**February 12, 2020 HRPB #20-00100006 Staff Report and Attachments**

HRPB#20-00100081: An Appeal of the Historic Resources Preservation Board's decision to approve the construction of a new single-family structure at 403 South M Street

**TITLE:** **HRPB Project Number 20-00100006:** Consideration of a Certificate of Appropriateness (COA) for the construction of a new +/- 2,361 sq. ft. single-family structure at **403 South M Street**; PCN# 38-43-44-21-15-157-0180. The subject property is a vacant lot located in the Single-Family Residential (SF-R) Zoning District and the Southeast Lucerne Local Historic District.

The Applicant has resubmitted plans for the construction of a new one-story, single family, +/- 2,361 sq. ft. residential structure, included in this report as **Attachment D**. The building is generally the same as it was when presented to the HRPB in 2017. The building will have public frontage on South M Street to the east. The building is not designed in a distinguishable style of architecture, though it may be considered contemporary. The building is proposed to be constructed of concrete block walls with a stucco finish, and a Boston-hip style roof in the front an

FRONT ELEVATION

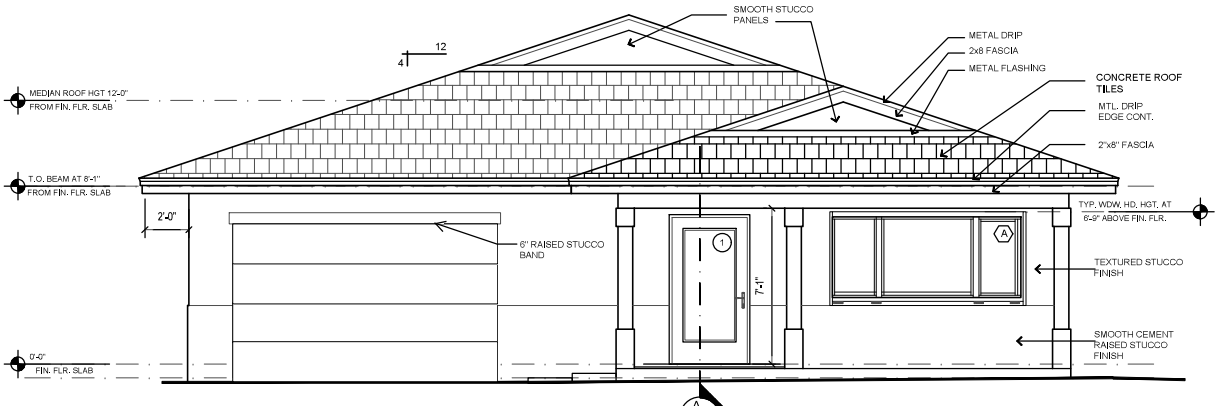
The proposal includes an oversized forward facing 1.5 car garage door on the south end of the front elevation that takes up nearly half of the front façade and is atypical for this district. Integral car garages are typically found on Masonry Vernacular or Masonry Minimal Traditional residences in the districts, but they are generally only 9'-0" wide, and are accompanied by other features that delineate these home styles; such as low-sloped hipped roofs, recessed front porches, divided light windows, and balanced facades. The current driveway is also 12'-6" wide, which maxes out the impermeable surface provision for the front yard. Staff recommends that the driveway be reduced in size so that a walkway connecting the house to the street can be included.

**Response:** The application as proposed does meet the minimum parking requirements, although the location of the garage and the driveway is typically located to the rear of related structures. Most structures in the Southeast Lucerne Historic District utilize the rear alley for parking and vehicular access to the structure. There is also no walkway which adequately addresses the street.

- 2) The garage door shall have a flush panel or recessed panel design, and shall not utilize raised panels.
- 3) The windows shall be recessed a minimum of 2" in the wall, and shall not be installed flush with the exterior face of the wall.

- 9) The driveway shall be reduced in size so that a walkway connecting the front door with sidewalk can be added without going over the front yard impermeable surface provision.

RIGHT SIDE ELEVATION

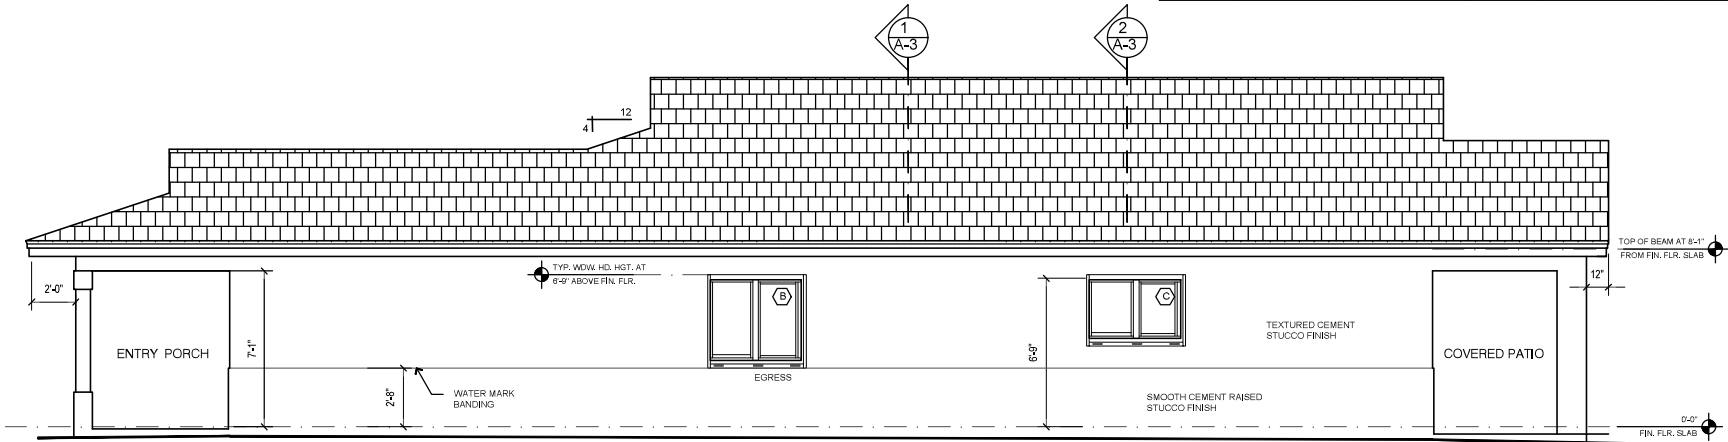
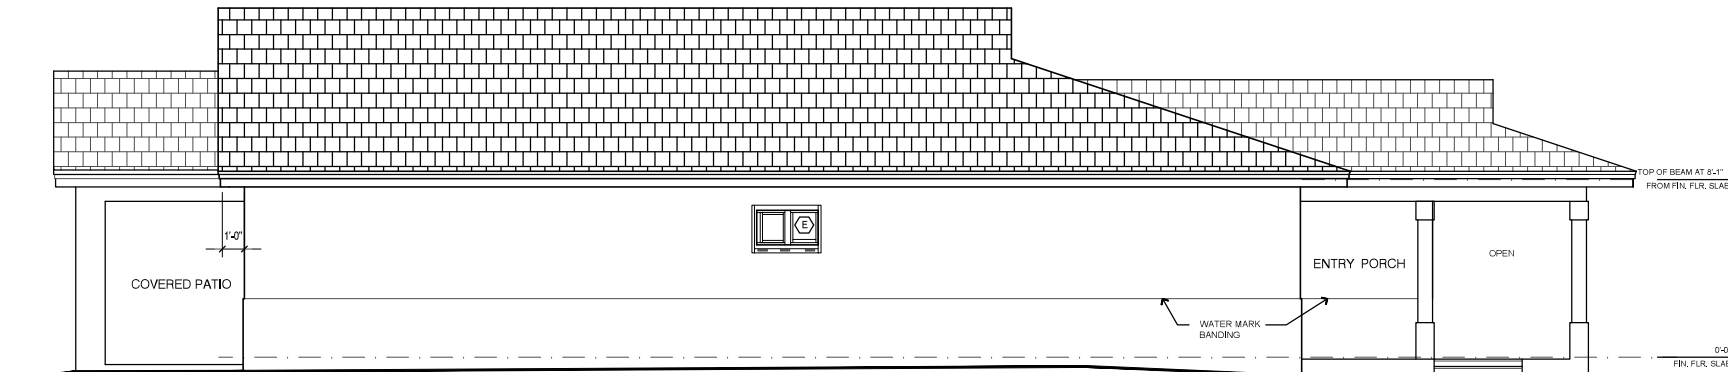
The proposed elevations depict long expanses of unbroken façades, particularly on the north and south facades, which have very few windows. Neighboring historic structures utilize many windows at regular intervals for light and ventilation into the structure. Staff has recommended that the Applicant add additional windows or details in order to avoid the long expanses of unbroken façades. The front porch on the drawings also has an atypical capital and base detail for the district. Staff recommends revised details for these decorative elements. The porch also could utilize railings or breezeblock accents for more detailing. The design does include a basic water table detail around the building; however, this detail is not a common façade feature in the districts.

**Response:** The proposed elevations depict long expanses of unbroken façades, particularly on the north and south facades. Too few window openings are proposed on these elevations, leaving the façades bare and visually incongruent with historic properties that typically utilized large windows at regular intervals.

- 7) Prior to permitting, the Applicant shall provide a Unity of Title document verifying the unification of the two lots.
- 8) Compatibly sized windows shall be added to the north and south facades to avoid the long expanses of blank façade.
